ABF-RFI-3351RD-SK1
RED LINE

SAN FRANCISCO OAKLAND BAY BRIDGE
EAST SPAN SEISMIC SAFETY PROJECT
SELF-ANCHORED SUSPENSION BRIDGE
(SUPERSTRUCTURE & TOWER)
E2 SHEAR KEY ANCHORAGE: GENERAL ARRANGEMENT

SK-3351R0-1

RFI: # 3351R0

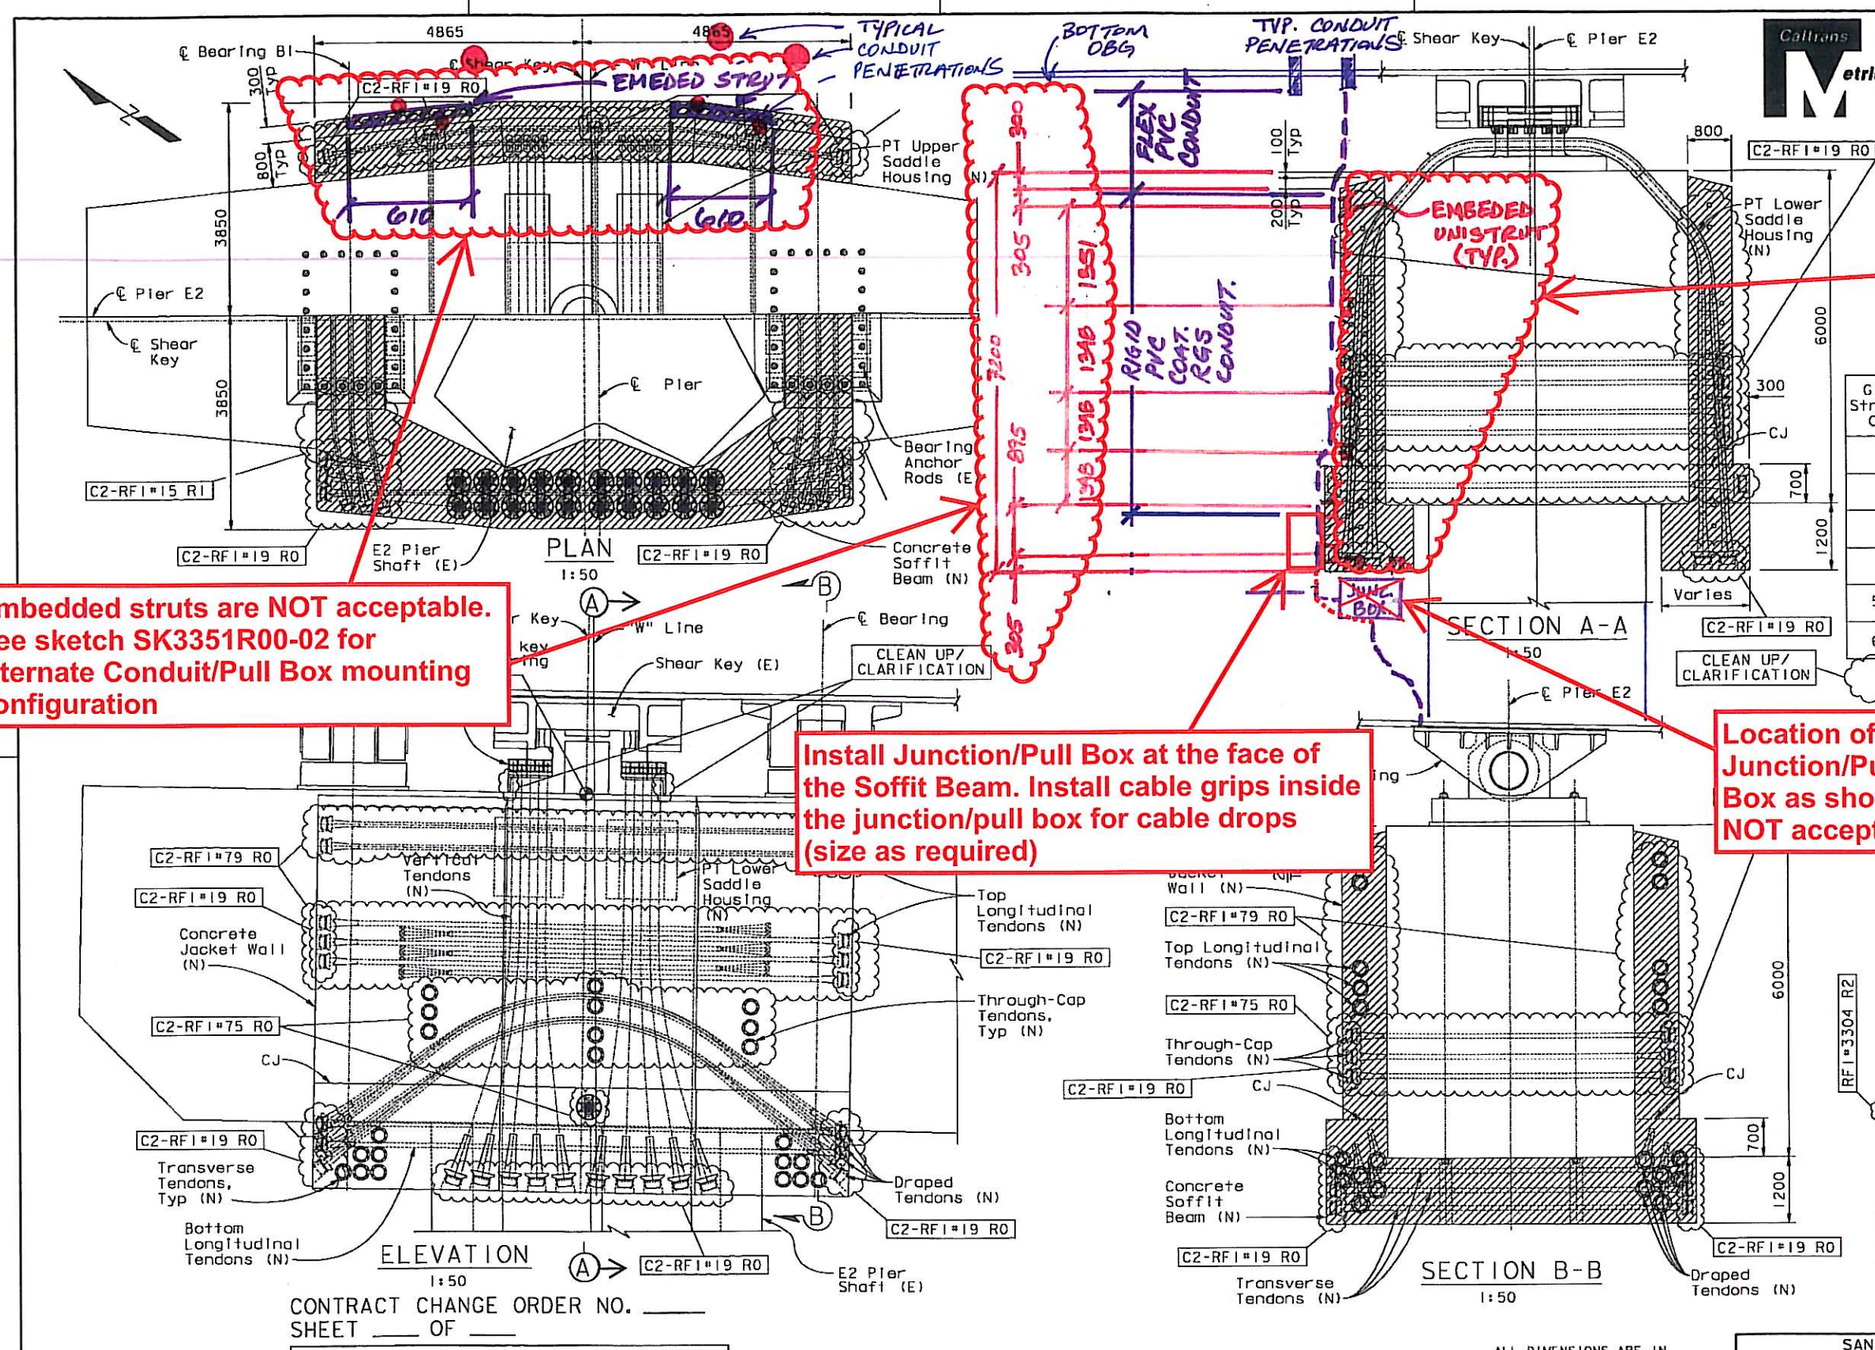
Embedded struts are NOT acceptable. See sketch SK3351R00-02 for alternate Conduit/Pull Box mounting configuration

Embedded struts are NOT acceptable. See sketch SK3351R00-02 for alternate Conduit/Pull Box mounting configuration

Install Junction/Pull Box at the face of the Soffit Beam. Install cable grips inside the junction/pull box for cable drops (size as required)

Location of Junction/Pull Box as shown is NOT acceptable
